Justification for Class III Permit Modification March 2006 SWMU 161 Operable Unit 1295 Building 6636 Septic System (Technical Area III)

Drain and Septic Systems (DSS) Solid Waste Management Units 49, 101, 116, 138, 140, 147, 149, 150, 154, and 161 (Poster 1 of 3)

**REQUEST FOR SUPPLEMENTAL INFORMATION
RESPONSE AND PROPOSAL FOR
CORRECTIVE ACTION COMPLETE FOR
DRAIN AND SEPTIC SYSTEMS SWMU 161,
BUILDING 6636 SEPTIC SYSTEM AT
TECHNICAL AREA III**

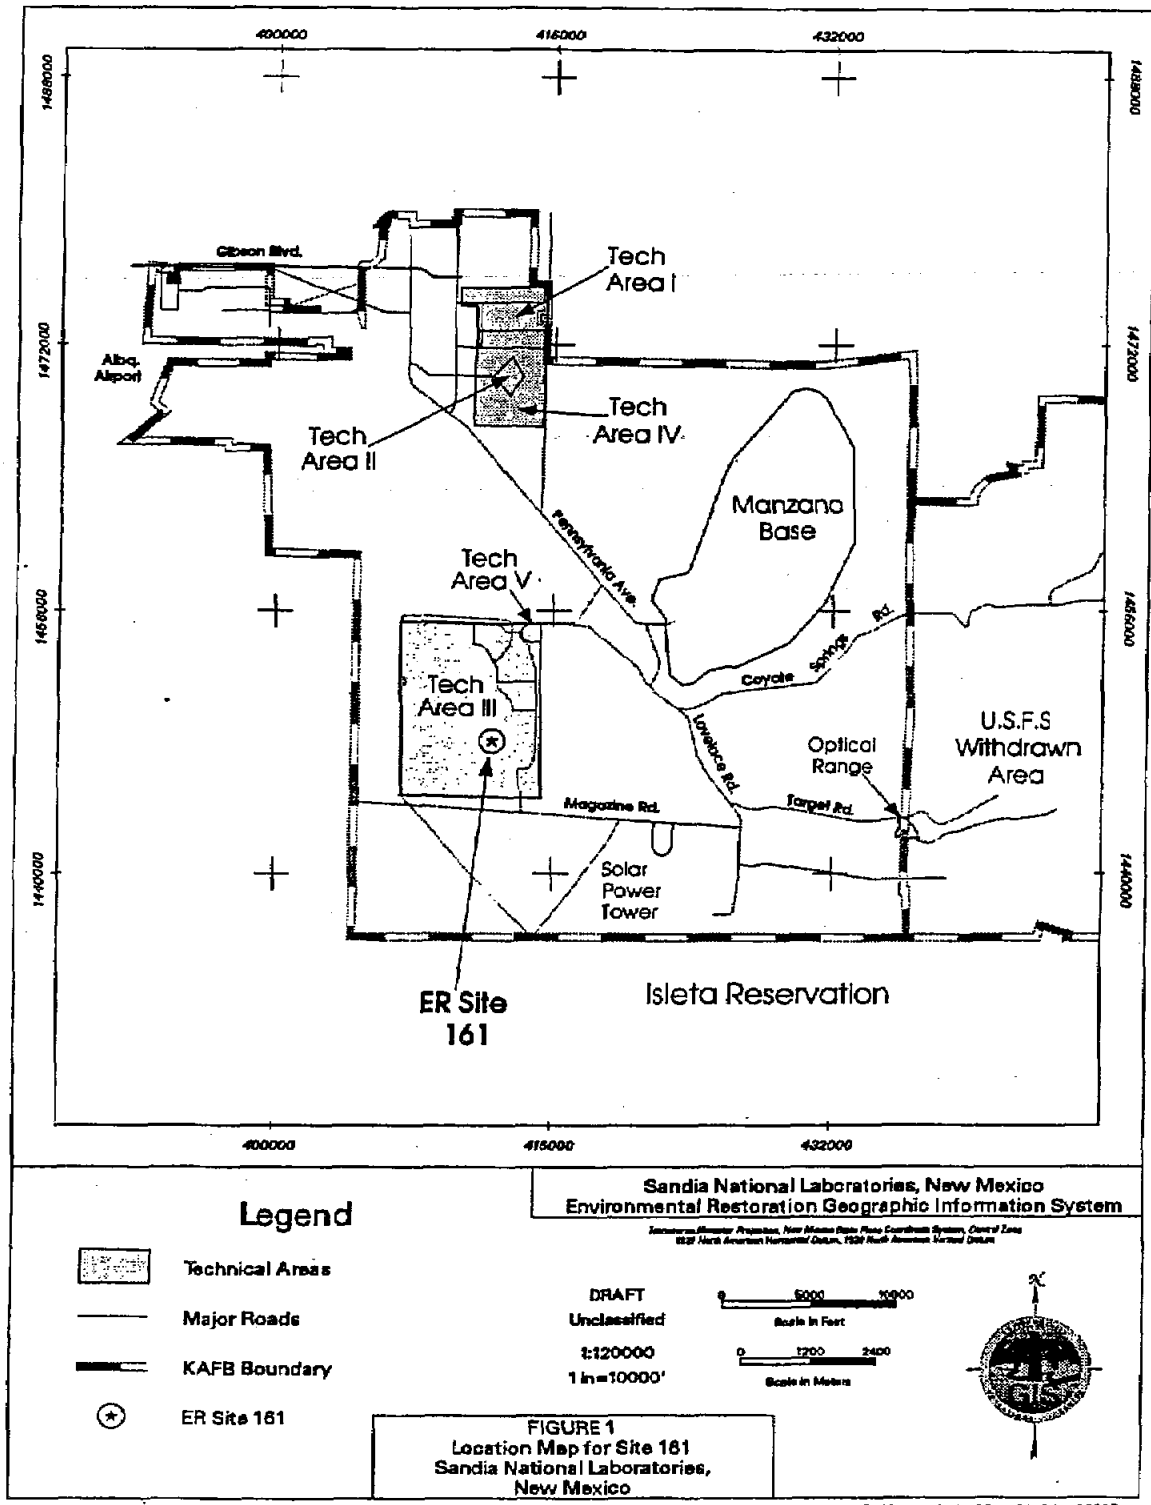
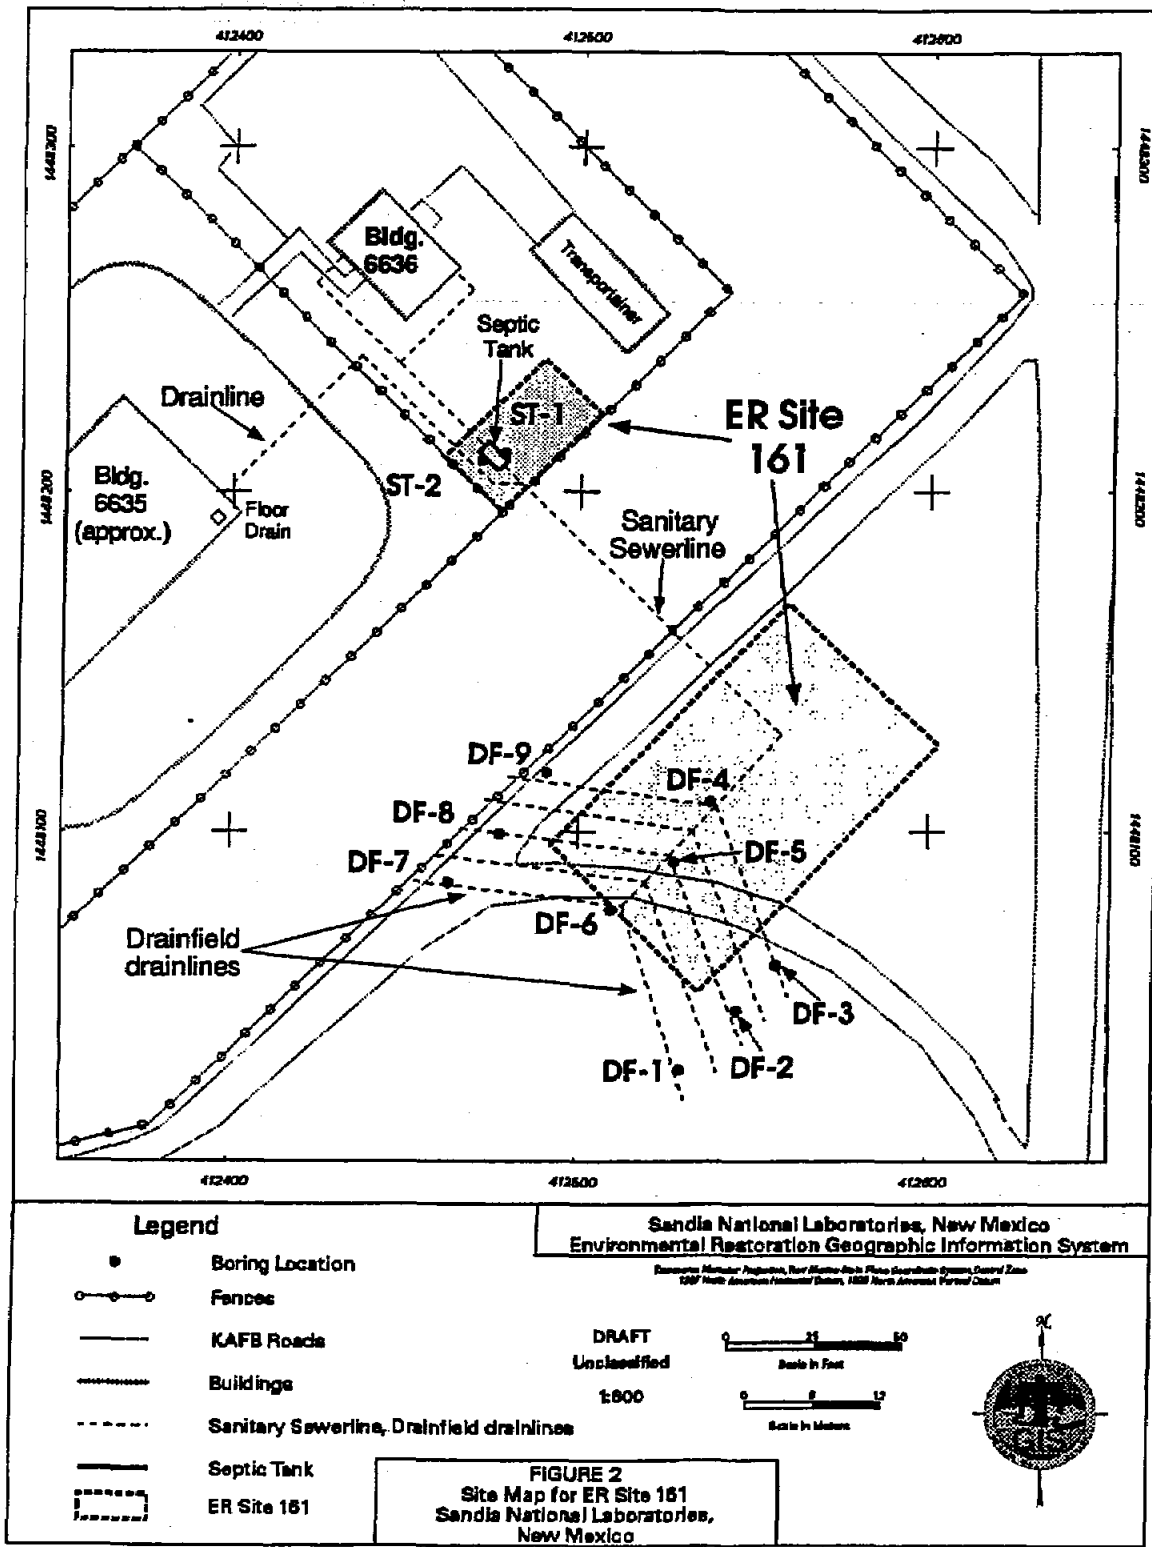
53. **Figures 1-1 and 1-2 - see General Comment 1.**

Response: See response to General Comment 1.

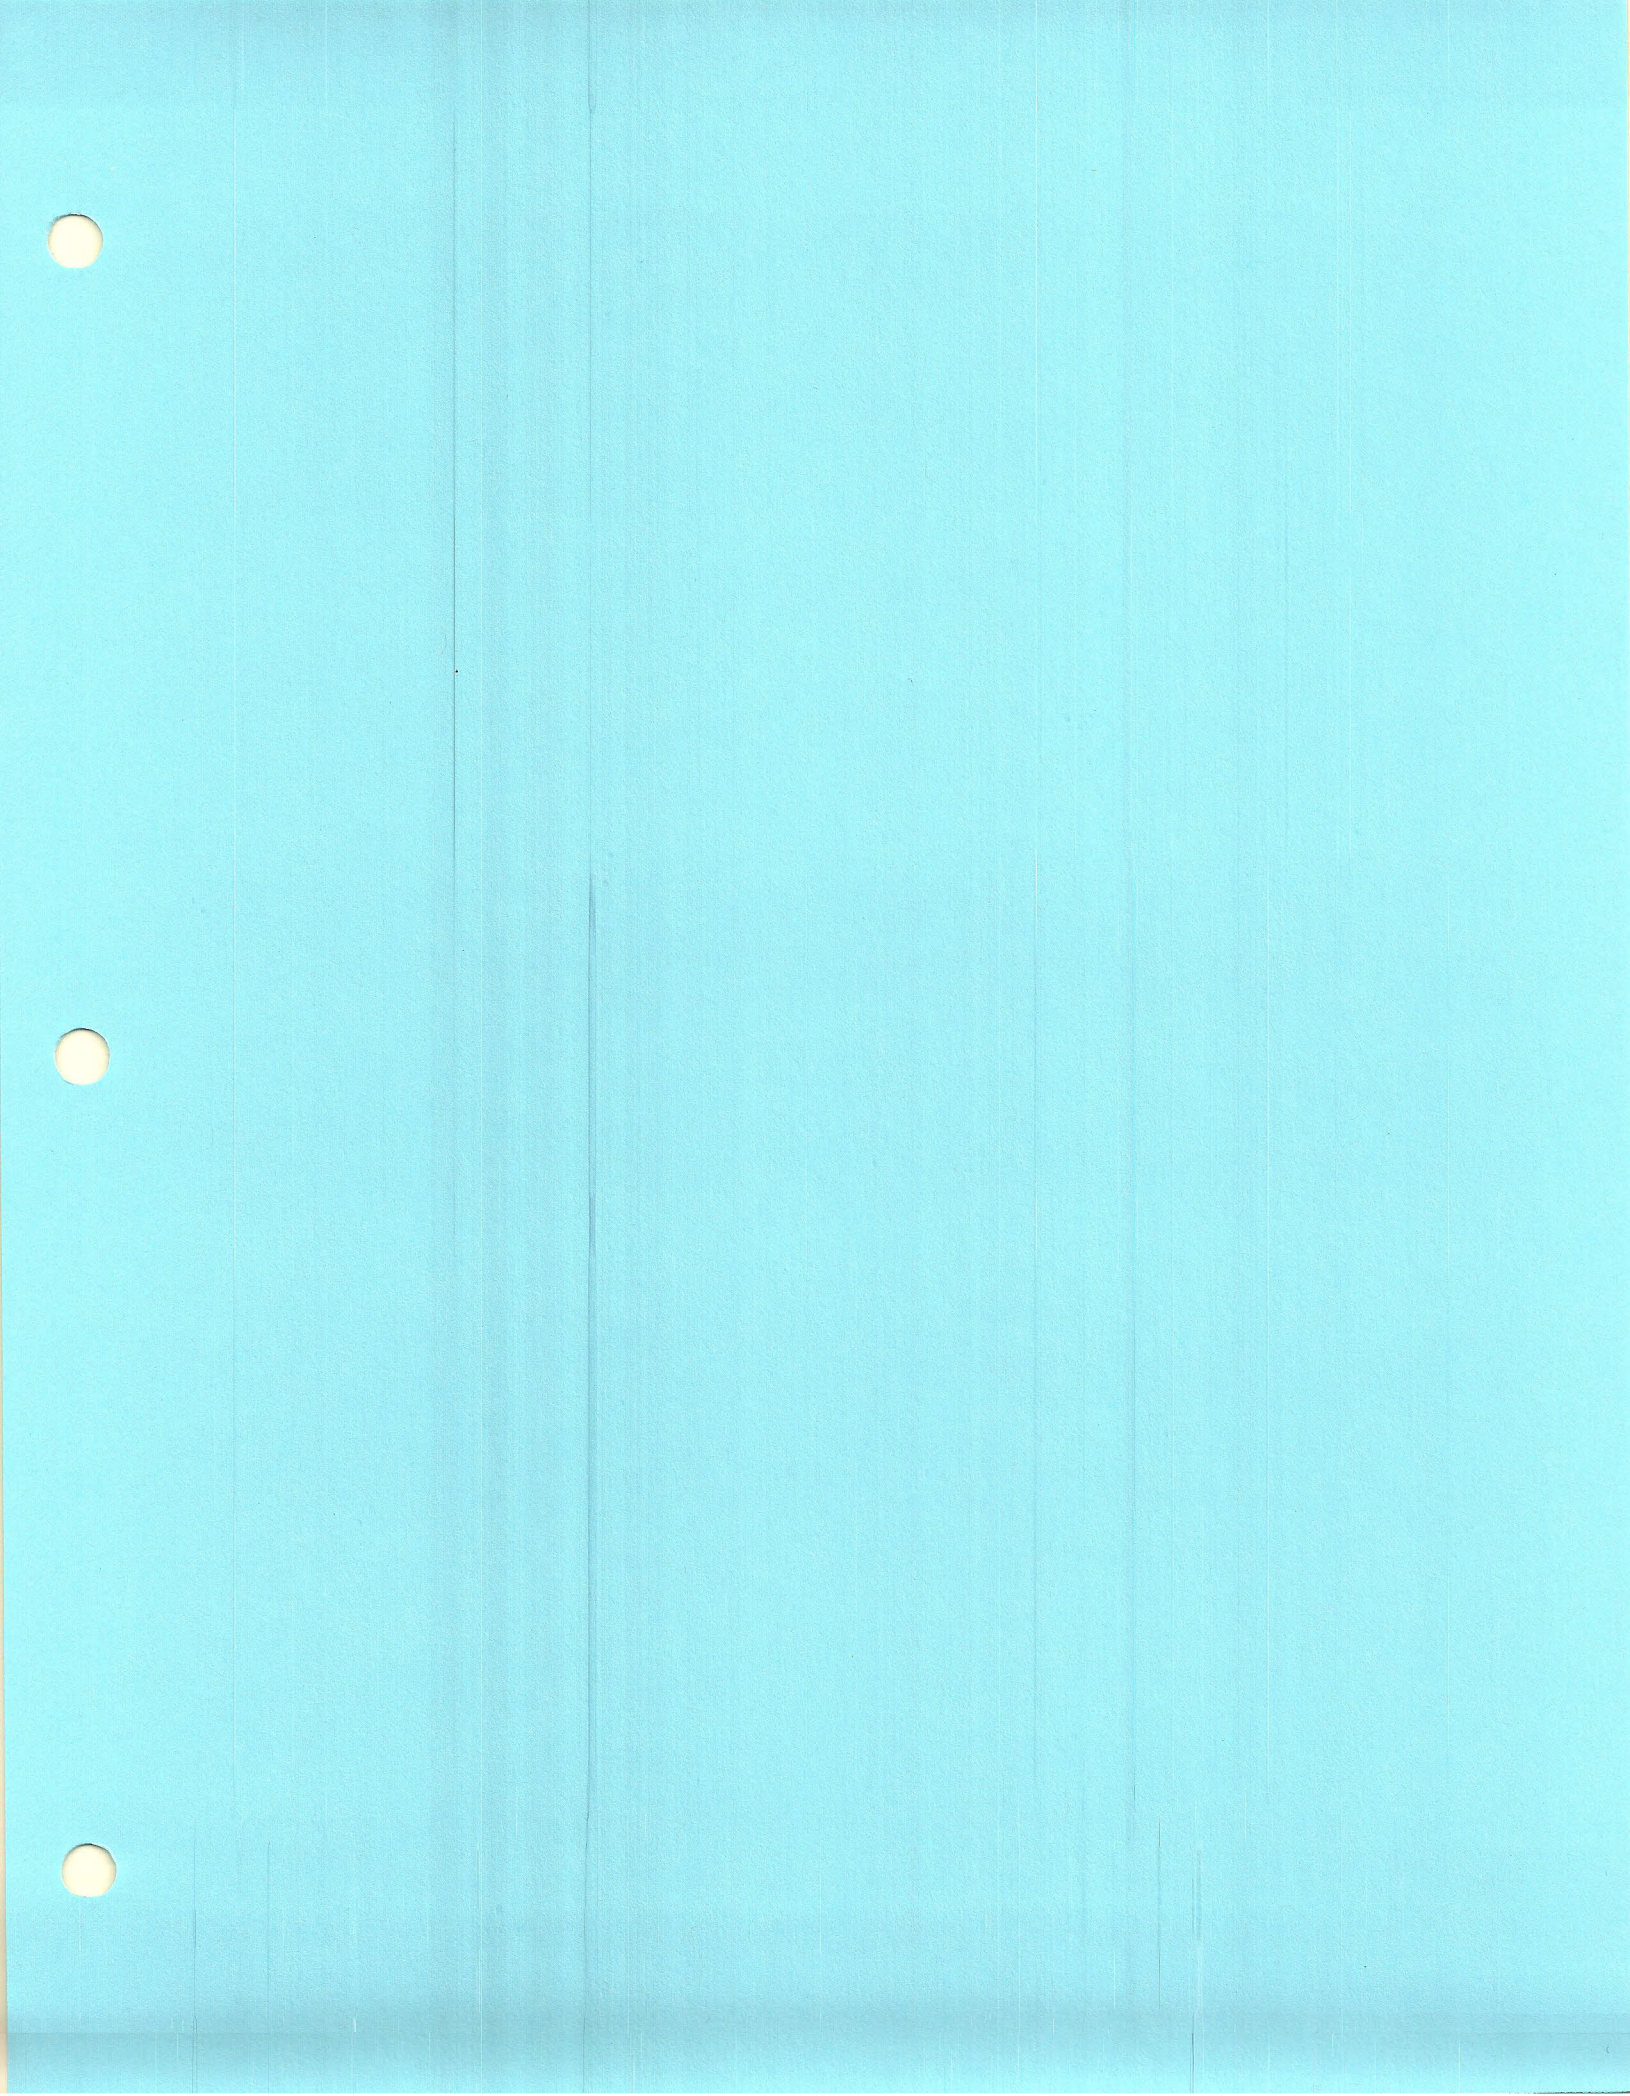
54. **PETREX SVS sample ID numbers on page A-13 do not match those on the figure on page A-14. The results of the PETREX SVS indicate plumes of PCE, BTEX, and aliphatics, or a combined plume may be underneath and/or migrating away from the drainfield. Sandia must complete boreholes at PETREX SVS locations 141 and 433, and install active or passive soil-vapor monitoring systems both at the surface and the bottom of the boreholes. Also, see General Comments 5 and 11.**

Response: The PETREX SVS results summary table on page A-13 of the NFA proposal for this site (for PETREX sample numbers 275 through 285) represent results of the first PETREX SVS that was completed between the inner and outer fences at the site. This first PETREX SVS was completed at this location because it was originally thought that the drainfield was located between

the two fences. However, the drainfield was subsequently located with a backhoe and was found to be actually located east and outside of the outer perimeter fence surrounding Building 6636. When the actual location was discovered, a second PETREX SVS (using sampler numbers 501 through 525) was completed in that area. These PETREX locations are correctly shown on the figure labeled "Appendix A.3" on page A-14 of the NFA proposal. The sample locations for the first PETREX SVS were not determined and mapped, because the survey was completed at the wrong location.

Analytical results for the second PETREX SVS (samplers P-501 through P-525) were inadvertently omitted from the NFA proposal for this site and are provided in Attachment D of the site-specific portion of this submission.

It is not clear to DOE/SNL which of the ER Site 161 PETREX locations are of concern to the NMED. There are no PETREX sample location numbers 141 or 433 in either the first or second PETREX SVS completed at this site. SNL suggests that the NMED review the analytical data for the second PETREX SVS provided herein. If necessary, the DOE/SNL and NMED technical staff can then meet to discuss any remaining concerns that may persist as a result of this additional PETREX data.
